**Amendments to the Drawings:**

**REMARKS**

The Office Action mailed February 1, 2007 has been carefully considered.

FIG. 1

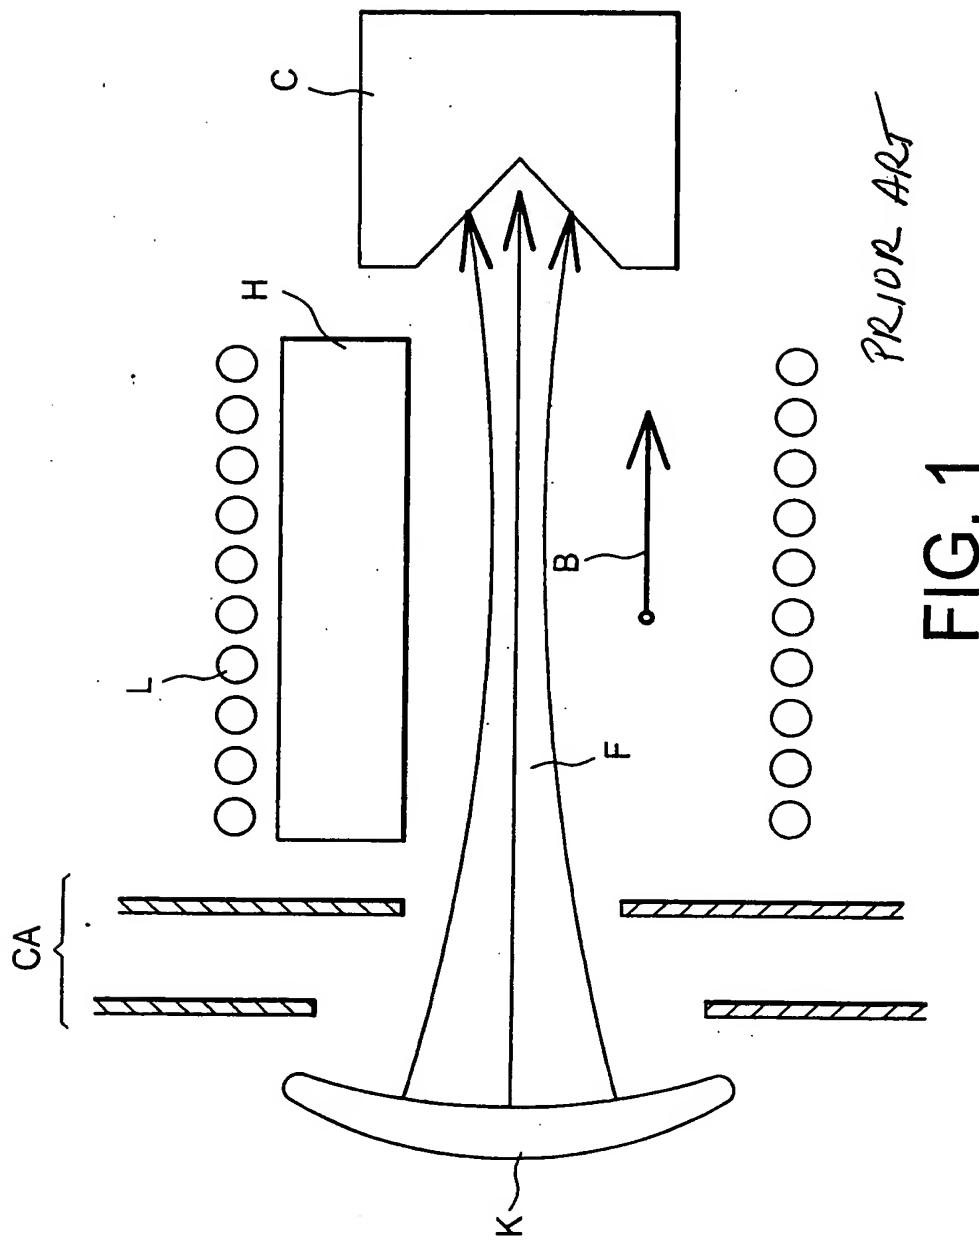
FIG. 1 has been amended to include the label --PRIOR ART--.

The drawings stand objected to for various informalities.<sup>2</sup> With this Amendment, paragraphs FIGS. 1 and 2 have been amended to be labeled “PRIOR ART.”

FIG. 2

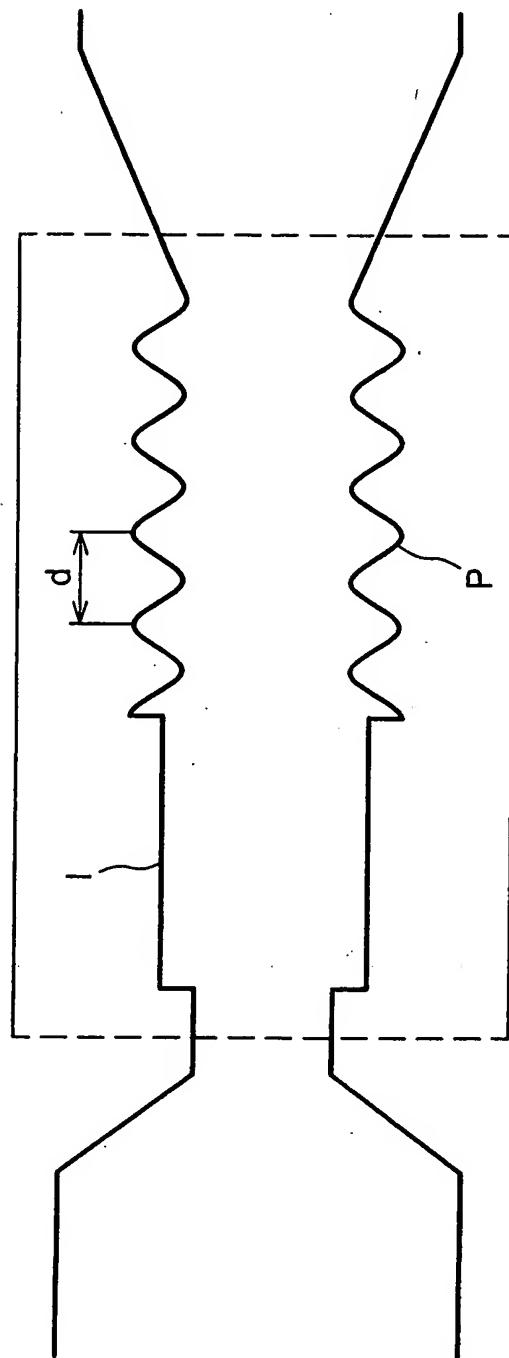
FIG. 2 has been amended to include the label --PRIOR ART--.

PRIOR ART
